## **Connah's Quay Low Carbon Power**

# **Applicant's Written Summary of Oral Submissions at Issue Specific Hearing 3 and response to Action Points**

Planning Inspectorate Reference: EN010166  
Document Reference: EN010166/9.19  
Planning Act 2008 (as amended)  
Revision 00

**FIGURE NUMBER**  
Figure 1

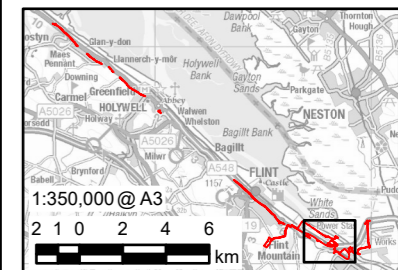
- 1.6.24 The ExA queried the current risks the site faces, site-specific sensitivity tests undertaken and the risk due to the infill and land-raising nature of the site.

- 1.6.26 *Post hearing note: please see the Applicant's response to Action Point 6, which presents the figure illustrating the above explanation.*
- 1.6.27 The ExA queried if specific investigation related to the infill of site itself.

- 1.6.25 Mr Walker-Springett explained that the Applicant has run a spatial data assessment of the coastal shoreline around the Proposed Development site, covering a timescale back to 1945, tracking the position of existing saltmarsh, and has found that the shoreline position has aligned itself in the last 23 years so that there was a portion of shoreline erosion on the down-estuary side of the site and accretion on the up-estuary side of the site, resulting in a two-sided feature since the original power station was built. Mr Walker-Springett noted that a figure had been prepared which could be provided with the written oral submissions. The shoreline appears to be in a semi-equilibrium stage, since 2018, with very little fluctuation. It is a very stable position at present. It changed a lot in the early 20<sup>th</sup> century and has now stabilised and the shoreline is now maintaining itself.

6	<p>Provide a copy of the figure referred to during Agenda Item 5.2.</p>	<p>Within Agenda item 5.2, Mr Walker-Springett explained that the Applicant has run a spatial data assessment of the coastal shoreline around the Proposed Development Site (specifically the Main Development Area), covering a timescale back to 1945. A figure which illustrates the findings of this data assessment is presented in <b>Appendix A</b>.</p>
7	<p>Clarify how any conflicts between the SMP and the Applicant's proposals</p>	<p>The <b>Applicant's Response to Deadline 3 Submissions (EN010166/APP/9.18)</b>, includes NRW's own response to ExQ1 14.2 which makes reference to the 'headline' SMP</p>
